From: Chronert, Roxanne N - DNR
Sent: Thursday, October 13, 2022 10:07 AM
To: Braun, Gary
Subject: RE: Piezometer Placement at F V Steel and Wire Site
Attachments: FV Steel - Red shaded exhibit.png

From: Saliars, Gwen N - DNR <gwen.saliars@wisconsin.gov>
Sent: Wednesday, October 12, 2022 3:25 PM
To: Chronert, Roxanne N - DNR <Roxanne.Chronert@wisconsin.gov>
Subject: Piezometer Placement at F V Steel and Wire Site
Importance: High

FV Steel - Red shaded exhibit.png

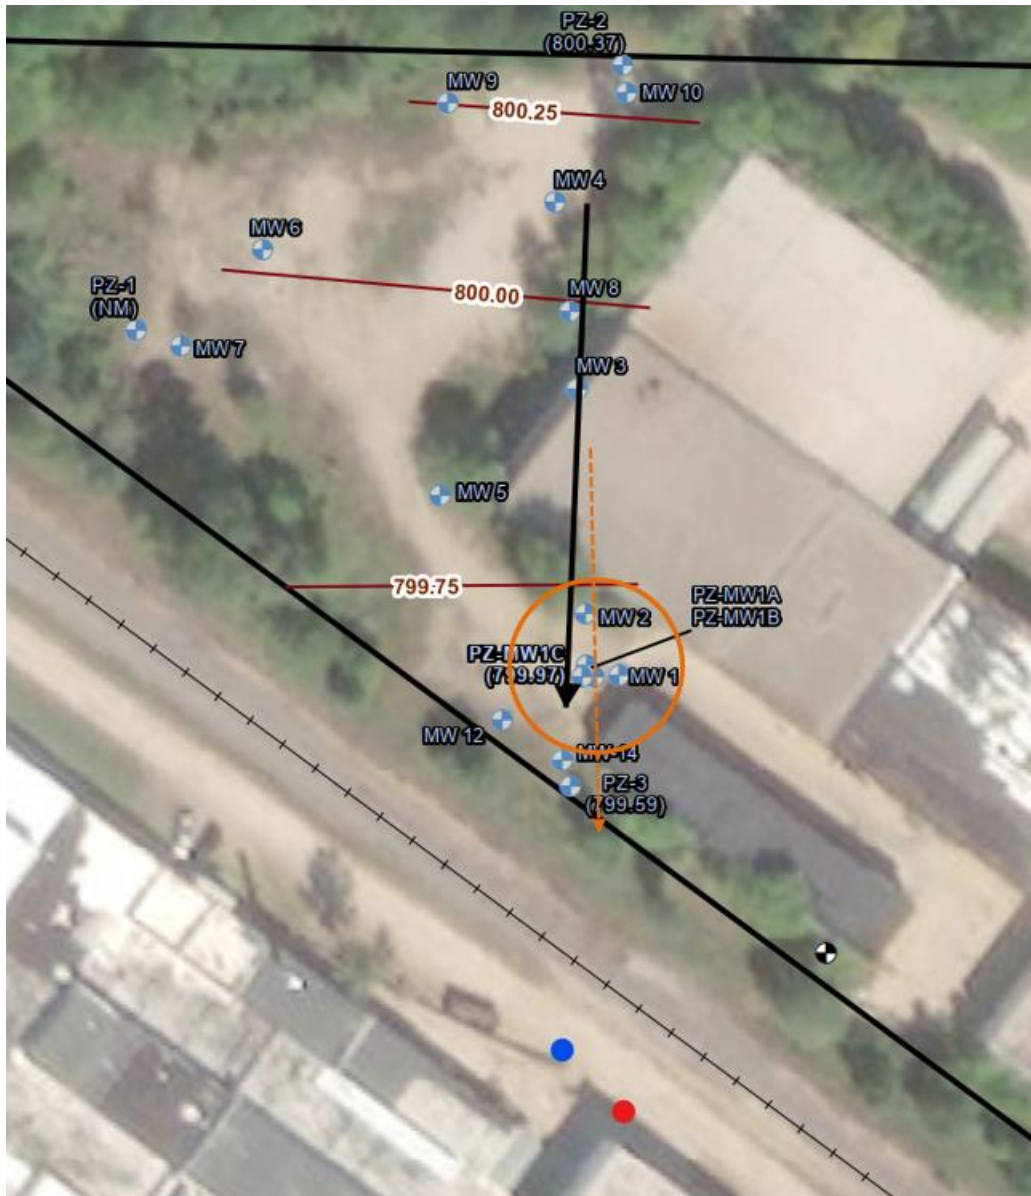
I understand the potential for concern. However, I think there may be a little too much emphasis on the flow arrow presented on the potentiometric surface at the bedrock interface to position PZ-7 (blue dot) since there are only three piezometers (which all happen to be parallel to flow direction). We are on-hold waiting to install several other piezometers (will mobilize along with offsite piezometer), which will certainly refine the potentiometric surface. If there is only a shift in the static potentiometric surface map (as small as 5-degrees counter-clockwise), the revised PZ-7 location (red) will be directly downgradient from the plume, which can be inferred to be within the solid orange circle. Note that I re-looked at the potential offset and figure we can get it within 30-ft of its original location (red dot). These assumptions also do not consider seasonal fluctuations, which would further increase the width of flowpath. It is for these reasons why I thought its reposition was satisfactory.

I spoke with 2 of the other NER Peer Review members, the piezometer needs to be placed in a downgradient location to define degree and extent at depth. It can probably be moved some to the east but 65 feet would seem to get it out of the direct flow path. If the PZ is placed out of the potential flow path, the sampling point would not serve much of a purpose.

The consultant sent me the email below about where the off-site piezometer can be located. Looks like the off-site property owner wants it moved farther east. The consultant doesn't believe that would be a problem, but I worry that may make it too far east to capture the deep groundwater plume. Would you be able to review and respond to the consultant? Reach out with any questions. Thanks,

- Client [landowner to the south] is concerned that the proposed location [of PZ-7] will impede and restrict access to the loading dock [as proposed in the attached image]. We request a minor revision to the well location to move it east between the red shaded building and the railroad tracks. See attached “FV Steel – Red shaded exhibit.” We hope you can accommodate this location change as it likely meets the intent of DNR direction to obtain a data point in this general area.

Looking at the site maps and aerials, I see us being able to get the deep piezometer installed within 65 feet of what is proposed in the attached figure. We concur with their assessment and request. We are set to install these piezometers this winter (already on Cascade’s schedule) considering funding has been authorized and changes to Access Agreement have been agreed to. We just need your buy-in on offset to PZ-7.

Gary, thanks for the further clarification and proposed location on the screenshot below. We concur with this proposed location.
